# REGULATORY INFORMATION DISTRIBUTION SYSTEM (RIDS)

SUBJECT: Forwards marked-up FSAR pages to show necessary changes, in addition to 860819 submittal. Summary of changes & explanation of each change to aid review of matl included. W/affidavit & 26 oversize encls.

August 22, 1986  
NMP2L 0851

As a result of Niagara Mohawk's verification of the Final Safety Analysis Report for Nine Mile Point Unit 2, we are submitting Final Safety Analysis Report pages marked to show the necessary changes. These changes are in addition to those in our August 19, 1986 submittal.

FIGURE 6A.4-41

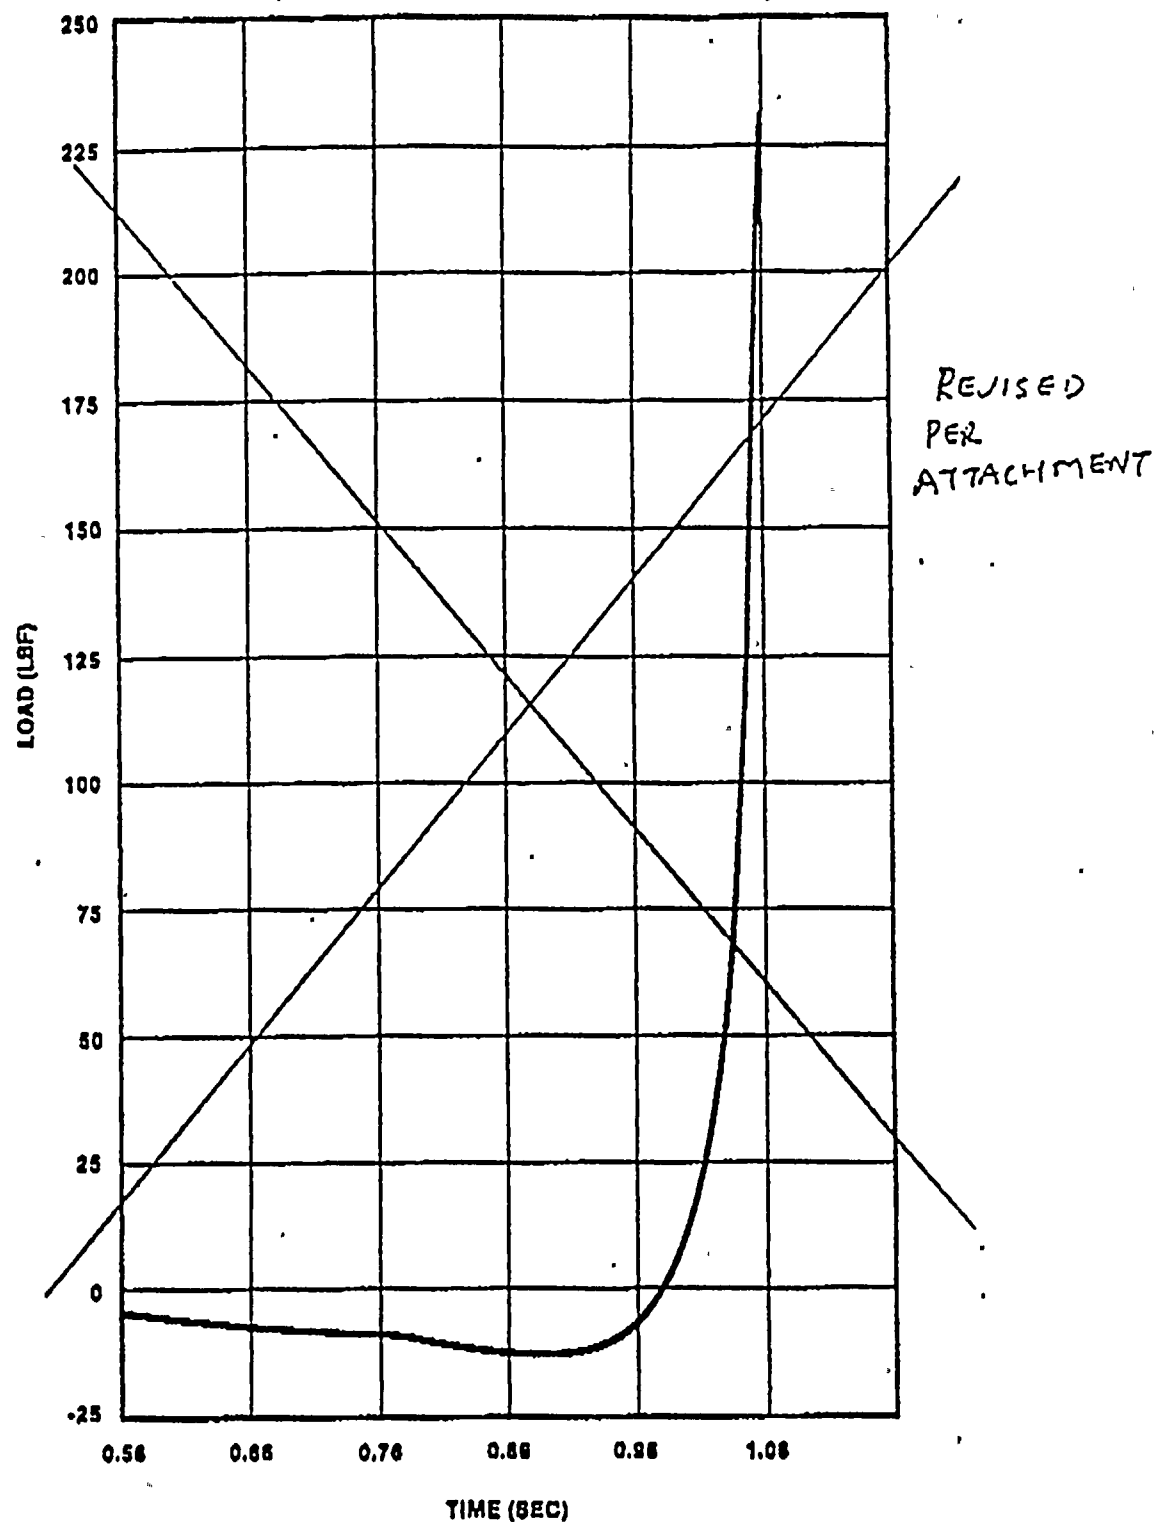
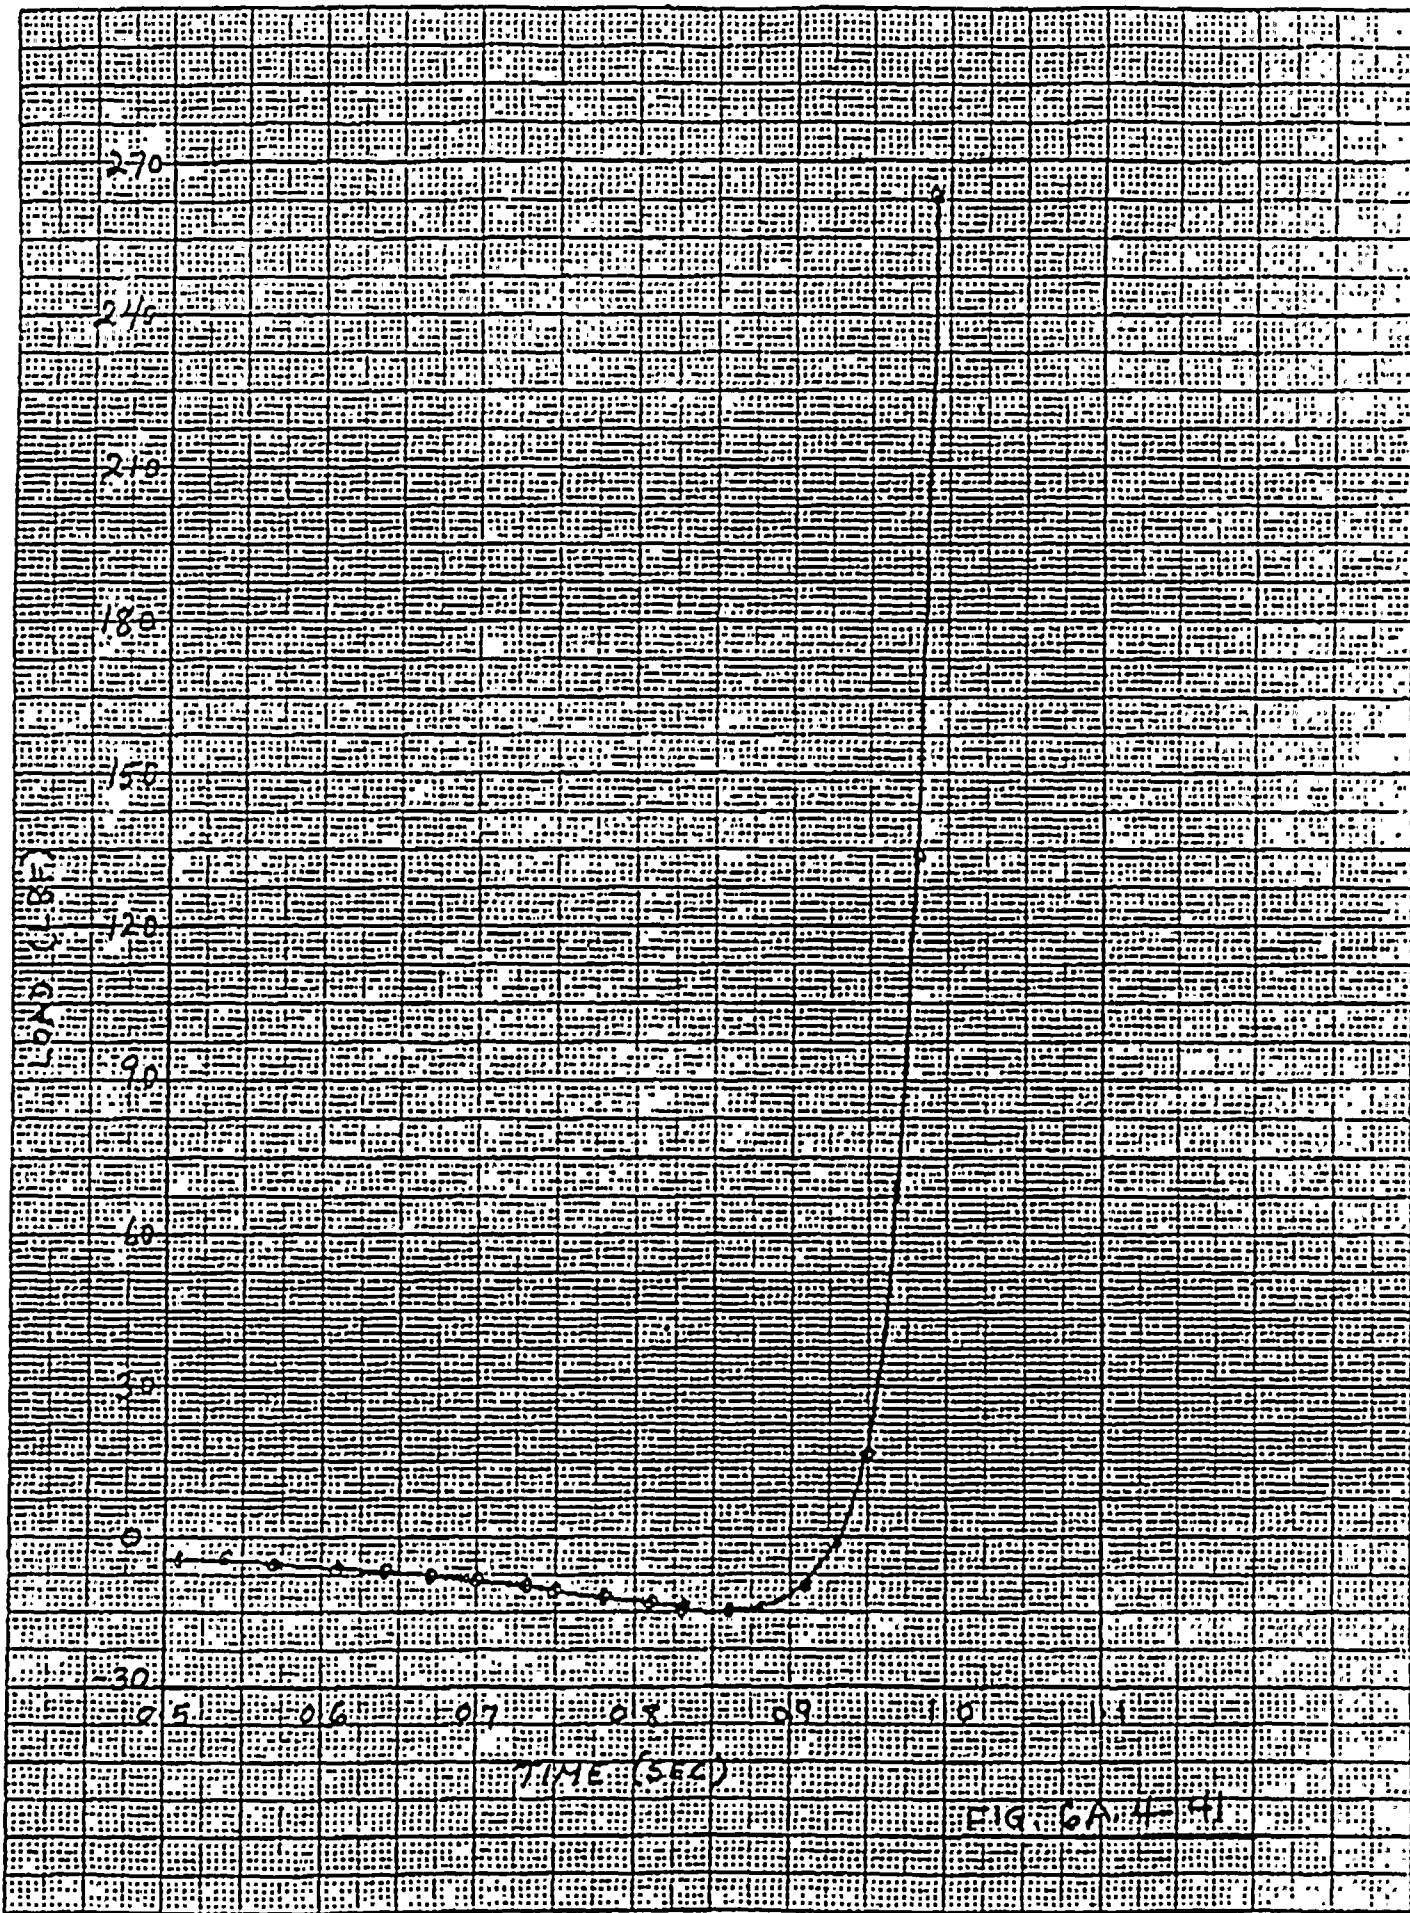
Page 6.5-9	Delete the sentence that mentioned the drywell and suppression chamber sprays rated flows.	The rated flows for drywell and suppression chamber as mentioned in FSAR page 6.2-46a.	E	No	No
Figures 6A.4-40 and 6A.4-41	Replace the figures with attached new figures.	The new figures reflect actual design.	E	No	No
Page 7.1-7	Change FSAR to committ to set-point methodology in FSAR.	Our letter #0604 dated 2/7/86 committed to include this in the FSAR.	R	No	No

FIGURE 9 1-20

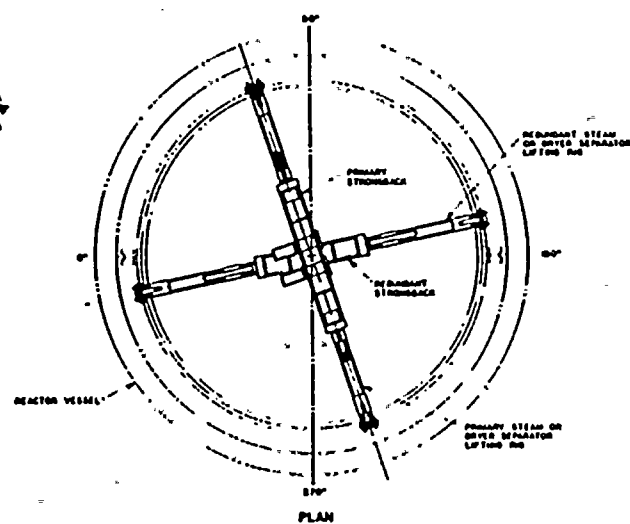
A separate sling set and lifting cruciform will be used when lifting the dryer and separator (Figure 9.1-20). These slings and the lifting cruciform are designed for underwater service. The cruciform structure is designed in accordance with the AISC Manual of Steel Construction.

FIGURE 9 1-19

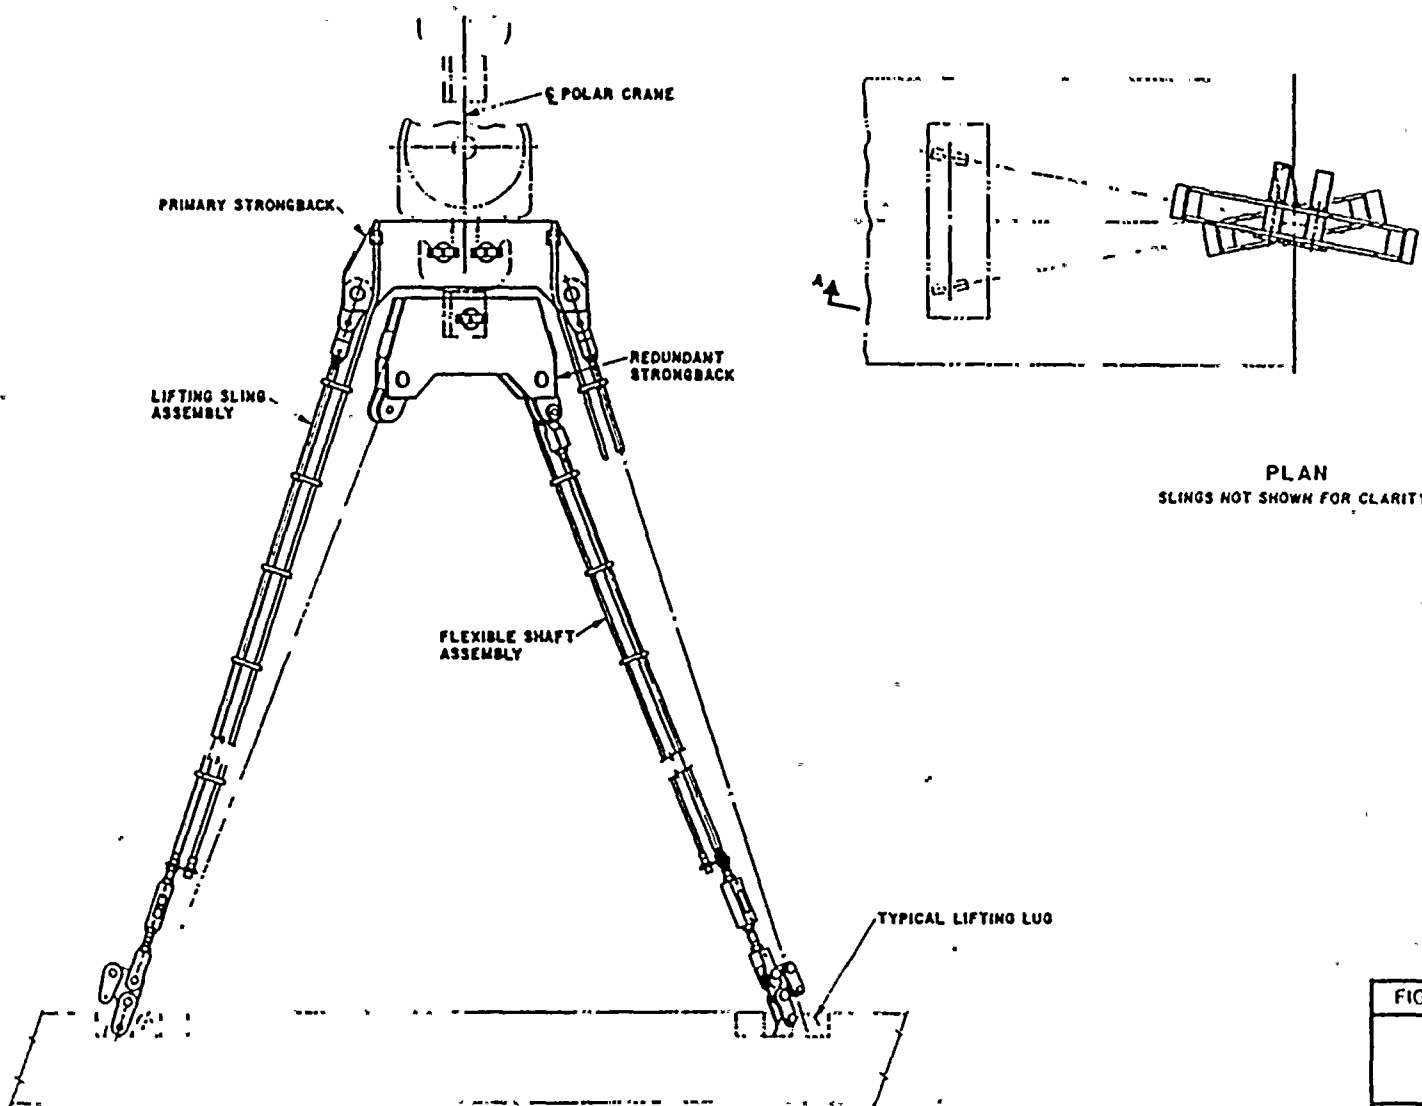
<u>Page</u>	<u>Change Description</u>	<u>Justification</u>	<u>Change Code</u>	<u>SER Impact</u>	<u>Tech. Spec. Impact</u>
Page 9.1-29	Revise description of lifting slings and strong backs.	Sling assembly is proof tested at 150 percent rated load. The slings are designed with safety factor of 3 times the rated load but not all slings are rated at 125 tons. Sling assemblies will be used to move other equipment. Spreader beams are used in lieu of a lifting cruciform.	E	No	No
Figures 9.1-19 and 9.1-20	Revision to figures.	Revision to these figures to match design drawings.	E	No	No
Page 9.2-9	Remove service water discharge pH and conductivity indications.	Continuous monitoring of pH and conductivity is not required.	E	No	No
Tables 9.2-1 and 9.2-2	Replace Tables 9.2-1 and 9.2-2 with the attached Tables 9.2-1A, 9.2-1B, and 9.2-2 with new formats to show required service water flows for Division I, Division II, and normal operation.	These changes are made to support the Technical Specifications.	E	No	No

Lifting slings (Figure 9.1-19) will be used in conjunction with the main strongback to lift and transport all critical loads during refueling. The slings and strongbacks are designed incorporating a safety factor of 3 times the rated load of 125 tons. The slings and strongbacks form a redundant lifting system. The slings are designed incorporating a safety load of 3 times the rated load.

SFC and WCS filter removal plugs, storage pool gate, service platform, and other critical loads. The sling lifting assemblies are solid bars with turnbuckles that independently attach to both strongbacks to facilitate distribution of load to all slings.

FIGURE 9A.3-3  
 FIRE PROTECTION ARRANGEMENT  
 UNIT NO.2 STATION BUILDINGS  
 PLAN EL 214'-0" & 215'-0"  
 NIAGARA MOHAWK POWER CORPORATION  
 NINE MILE POINT-UNIT 2  
 FINAL SAFETY ANALYSIS REPORT

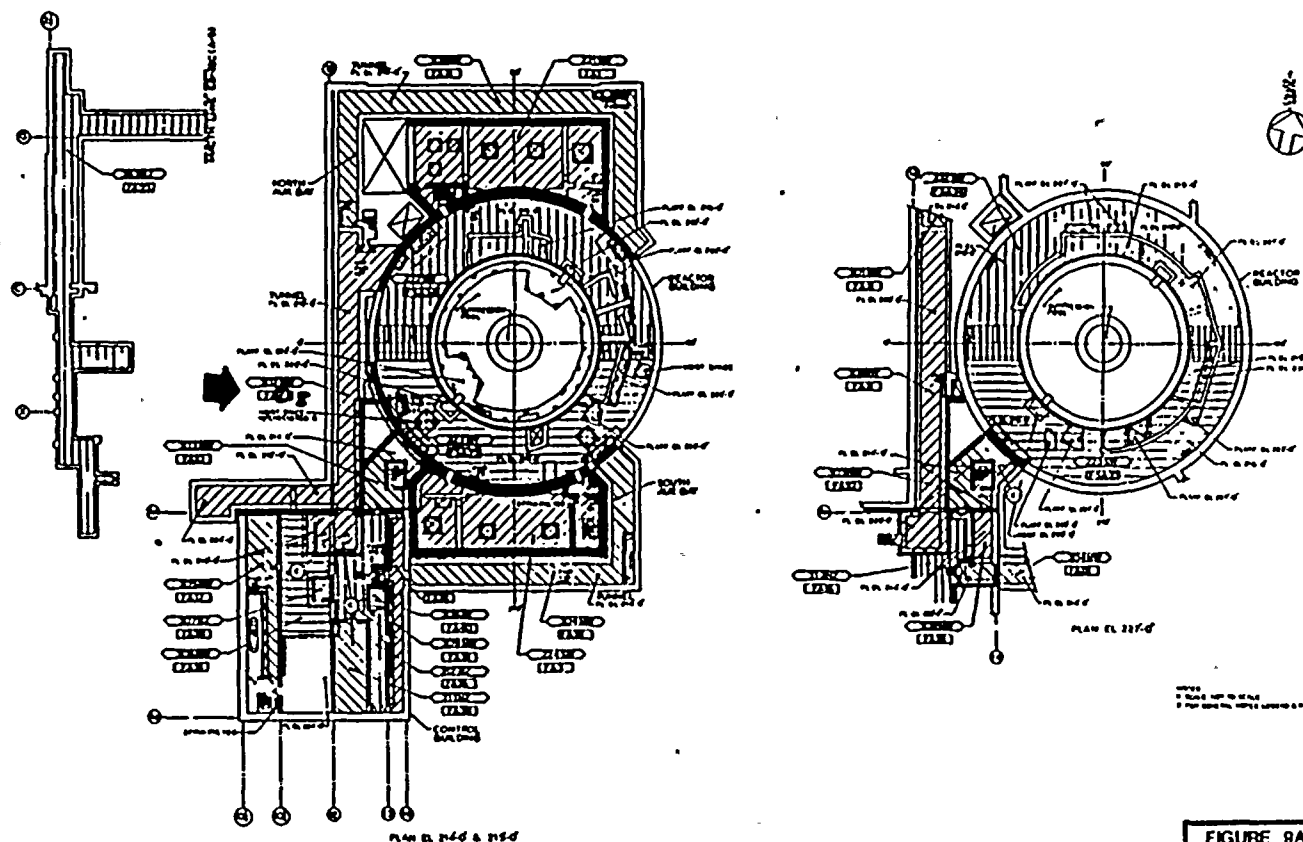
Figure 9A.3-3	Change the fire area designation in the figure.	The change reflects actual configuration of the fire designation.	E	No	No

**FIGURE 9A.3-14**

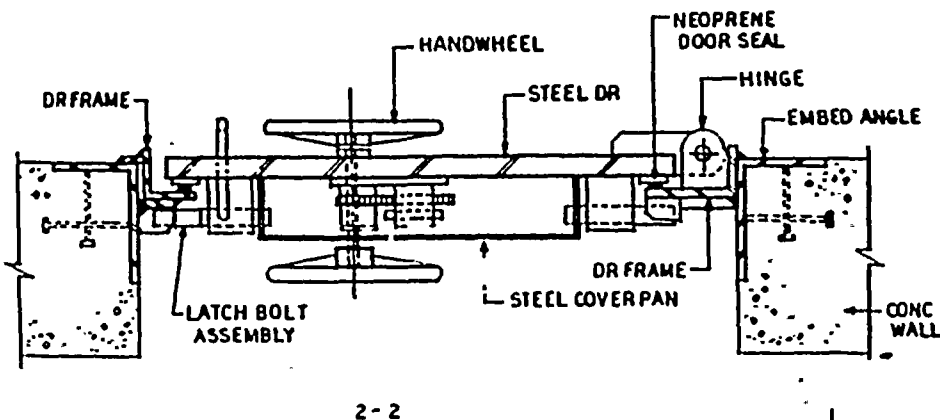
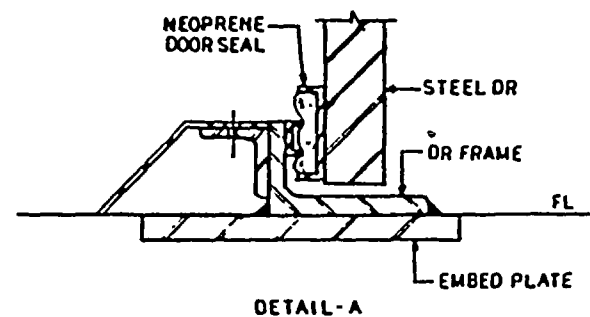
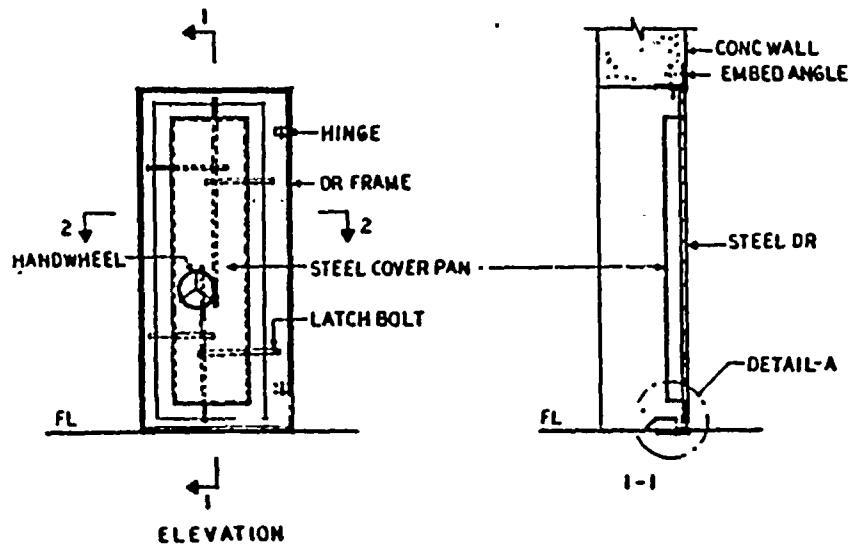
<u>Page</u>	<u>Change Description</u>	<u>Justification</u>	<u>Change Code</u>	<u>SER Impact</u>	<u>Tech. Spec. Impact</u>
Figure 9A.3-14 Pages 1 and 2, Figure 9A.3-15 Pages 1 and 2, Figures 9A.3-16 Pages 1 and 2, Figures 9A.3-17 Pages 1 and 2.	Replace reference to page 1 of the figures with door identifications. Delete page 2 of the figures.	Page 2 of the figures are deleted. The information in page 2 of the figures are already provided in Table 9A.3-17.	E	No	No
Table 9A.3-16 Pages 1 and 2	Modify existing information in the area of fire loading.	These changes reflect as-built condition.	E	No	No
Table 9A.3-17 Pages 1 to 3	Delete reference to radiation shield and pressure tight for special purpose doors. Expand table to incorporate additional comparison of non-labeled doors.	This change reflects as-built condition.	E	No	No
Page 9A.3-42	Change the description of the door opening.	This change reflects the as-built condition.	E	No	No

**DELETE  
ENTIRELY**
